**foundation
investigation and
design report**

Jersey Creek Concrete Culvert
at
Hwy. 407/CPR Subway

W.P. 141-87-00C

JERSEY CREEK CULVERT - SHAFT

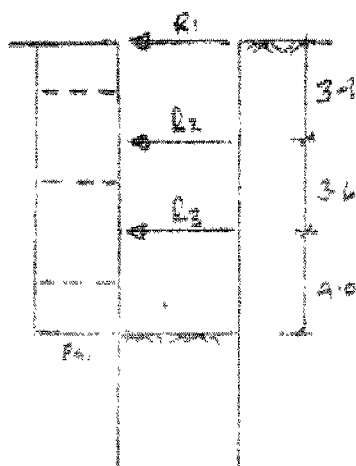
- Discussed attached calcs w. Bob Jeffries on 1993 03 18 PM.
- If Fenco's calcs indicate that a couple of walers are to be strengthened, they can propose that.
- Use of 0.35, with min. (>1.0) FS.
- Use of 0.2 may work, provided there is an arching effect.
- Acc to Bob. J., the shaft has already been constructed !! He is going to the site to verify this.
